UNITED STATES
NUCLEAR REGULATORY COMMISSION
WASHINGTON, D.C. 20555-0001

SUBJECT: SUMMARY OF AUGUST 25, 2022, PUBLIC OBSERVATIONAL
MEETING WITH HOMESTAKE MINING COMPANY OF
CALIFORNIA TO DISCUSS THE LICENSE AMENDMENT REQUEST
FOR BACKGROUND MONITORING LOCATION CHANGE FOR
RADON AND AMBIENT GAMMA RADIATION

**U.S NUCLEAR REGULATORY COMMISSION AND HOMESTAKE MINING CO. OF CA
PUBLIC OBSERVATIONAL MEETING, BACKGROUND MONITORING LOCATION CHANGE
FOR RADON AND AMBIENT GAMMA RADIATION LICENSE AMENDMENT REQUEST,
GRANTS RECLAMATION PROJECT, AUGUST 25, 2022**

Figure 1 - Current public dose monitoring locations (HMC-4, 5) and Background radon (HMC-16)

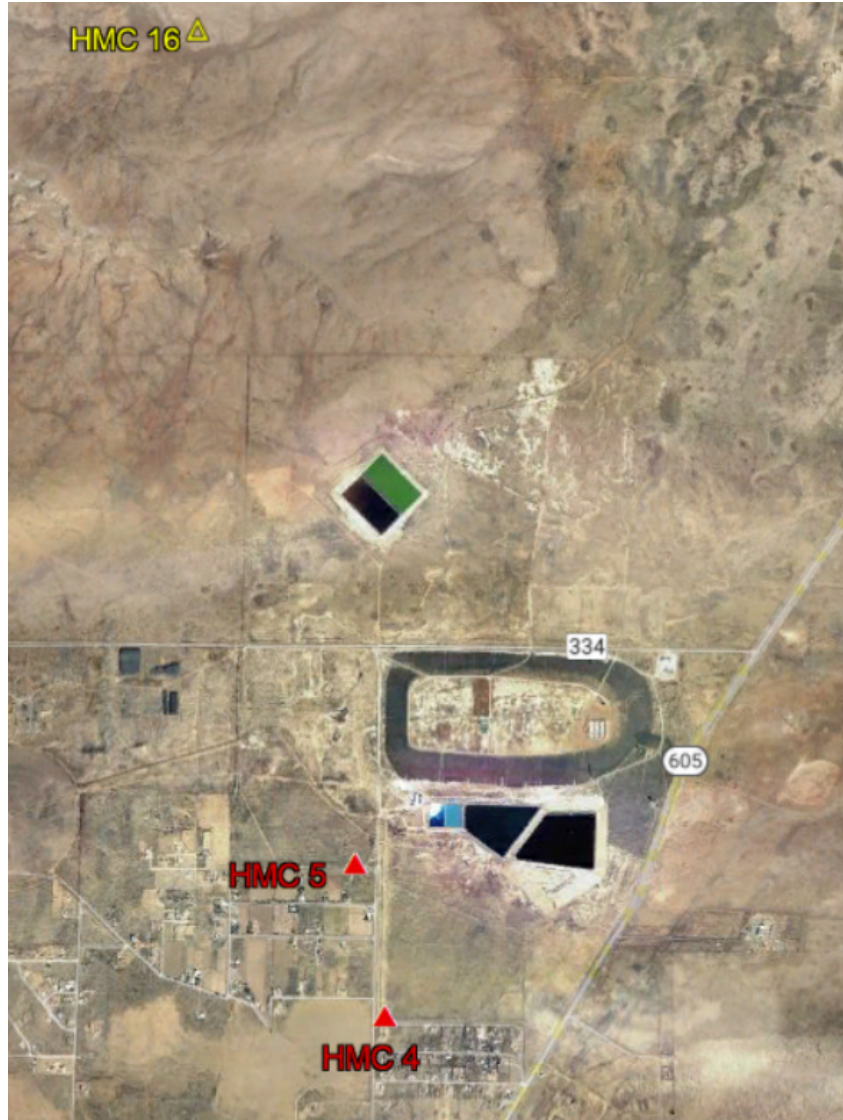
In its December 18, 2020, submittal, the Homestake Mining Company of California (HMC, or the licensee) requested a license amendment to change the location of the background radon and gamma monitoring station. The reason for proposing this change was that HMC determined that the current background monitoring location (HMC-16) is biased low compared to the background radon concentration at the points of public dose calculation (HMC-4, 5). According to HMC, this low bias results in a higher calculated public dose than a location(s) that is more representative of the points of public dose calculation. See Figure 1 for locations.

Figure 17. Regression of the measured radon concentration vs. the predicted concentration without background for the short-term dataset.

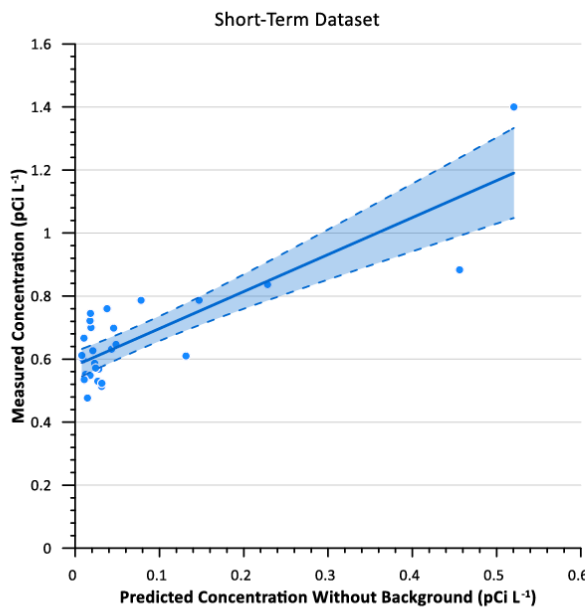
HMC's Figure 17, Predicted vs. measured radon values:

- NRC staff does not see the relevance of this figure for determining a specific background radon value at HMC-4,5.

- Study cited by HMC characterized natural radon emissions in terms of an estimated range of background radon concentrations based on monitoring data.
- Monitoring data from emissions in cited study was distributed over approximately 70 square kilometers (km²)(27 square miles (mi²).

- Monitoring data from HMC emissions (R1, R2, R12, R15) distributed over approximately 1.2 km² (0.5 mi²).
- The majority of monitored locations used in the HMC analysis are distributed within the previously remediated or disturbed areas.

- It is not clear to the NRC staff how HMC can derive a background radon value using data from remediated areas, then apply that derived value outside of the remediated area (HMC-1OFF). HMC's position has been that a background monitoring location impacted by the remediated or disturbed areas is not appropriate.

- It is not clear to the NRC staff that the R1 location (top of large tailings pile) exhibits the same influences of background radon as other locations.
